## The Corporation of the District of Saanich

# Report

**Subject:** Development Permit Application - 4211 Commerce Circle

**File:** DPR01055

**Figure 2: Site Plan**

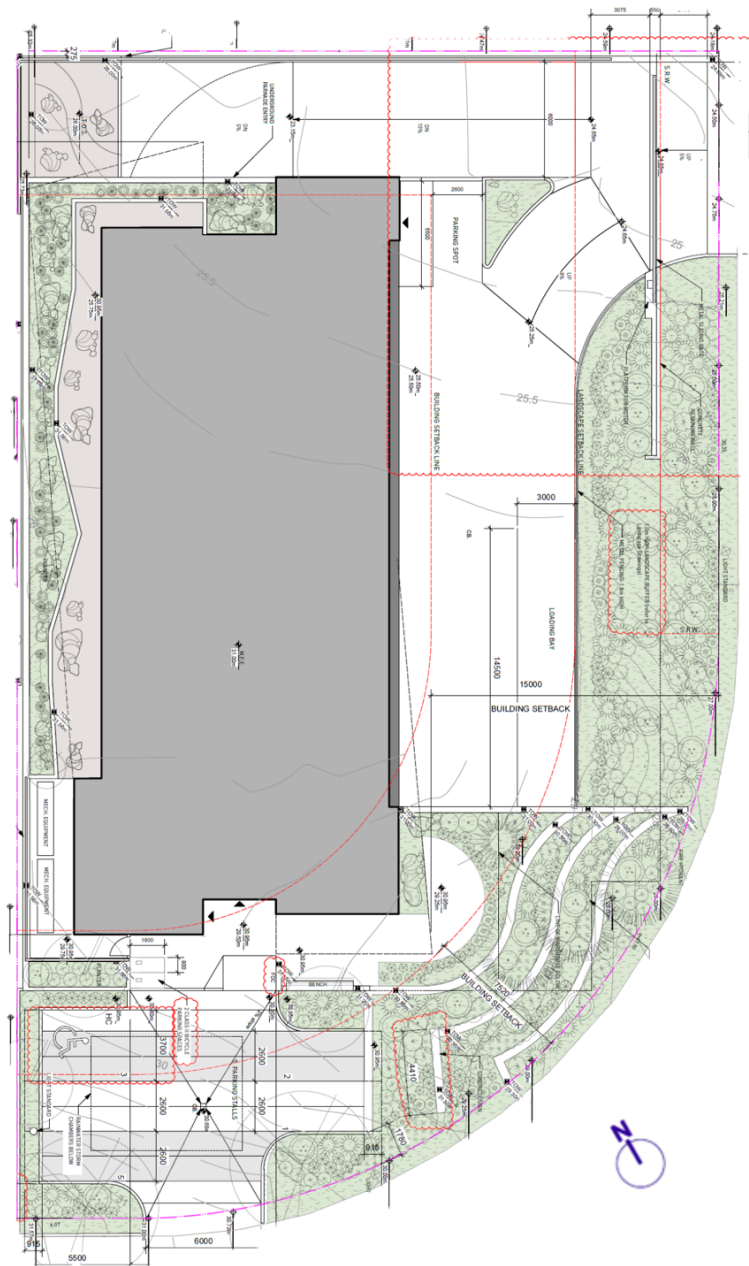
The application was considered by the Advisory Design Panel (ADP) at their February 5, 2025, meeting at which the design team was commended for their thoughtful and well executed approach to the project. The ADP moved “That it be recommended that the design to construct a 3-storey mixed use building (office and warehouse storage) at 4211 Commerce Circle be approved subject to considerations of:

- Softening the visual impact of the retaining walls and fencing”

There is an approximately 6.0 m grade difference on the site from south to north. The office entrance and visitor parking are located at the south entrance of the site at grade providing a public entrance from the street. The entrance to the warehouse level, loading space and underground parking is located at the lower, north end of the site. With recognition that the retaining walls and fencing are necessary to retain soil for landscaping and for the safety of users of the site due to the significant grade change, the ADP suggested that softening the visual impact may include changing the colour of the fencing to coordinate with the tones of the building behind or lowering fences and guards where possible (without impacting the safety of the site or zoning bylaw requirements), to reduce the visual impact of the fencing and to allow the landscape and architectural elements to take prominence.

A 7.5 m landscape buffer and 1.8 m fencing has been provided along the Commerce Circle frontages, except for the two driveway areas, to visually screen the warehouse and loading areas from the street. Over time, the impact of the fencing and some of the more visually dominant walls is expected to soften as the vertical greenery planned in these locations matures. Outdoor areas with landscaping, seating, and weather protection are provided including a balcony on the second storey with covered outdoor seating space for employees. A covered bench is also located at the office entrance. The extensive landscaping helps to soften the interface between the built form and the surrounding uses.

In response to the ADP comments, the applicant has indicated that they do not intend on making changes to the plans at this time, but based on the ADP discussion, will be reviewing the heights and colours of the fence and guards. A change to the fence colour may be pursued through an inconsequential change to the Development Permit at the time of building permit application.
